**SUBJECT: Application for Amendment to Existing REA 5186-9HBJXR
Grand Bend Wind Farm - Request for Trial to Modify the Blades on Two Wind Turbines with Noise Reduction
Add-Ons (F-Type DinoTails, Vortex Generators) and if Successful, Implement the Change at all Turbines**

Modification Document

Wind Turbine Blade Noise Reduction Add-on Upgrade Trial

Figure 1: Siemens Gamesa Renewable Energy D-type and F-type Dinotails

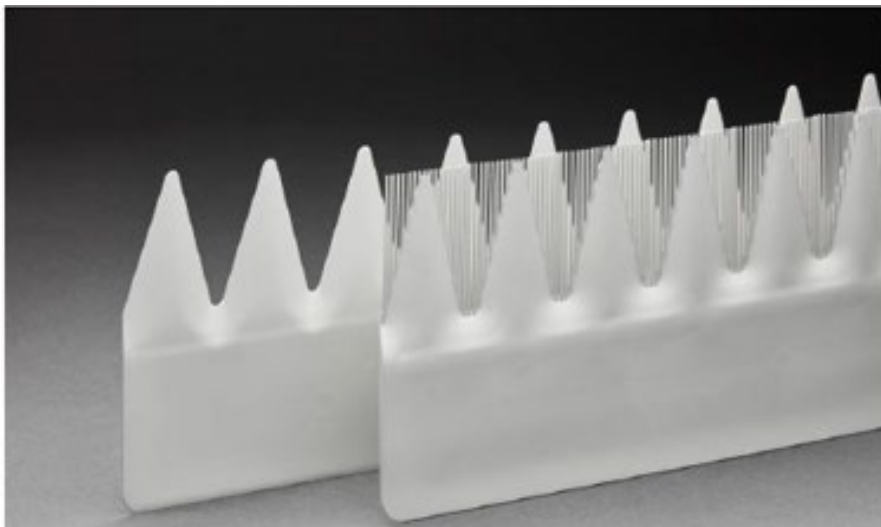
Northland proposes to modify these add-ons by relocating the D-type Dinotails to the mid-span area of the turbine blade and add new F-type Dinotails and additional Vortex generators at the end section of the turbine blade. The two types of Dinotails are shown below.

The original D-type serrated Dinotail is shown on the left, and the F-type Dinotail (with the fine combs added to the serrations) is in the front/right of the image.
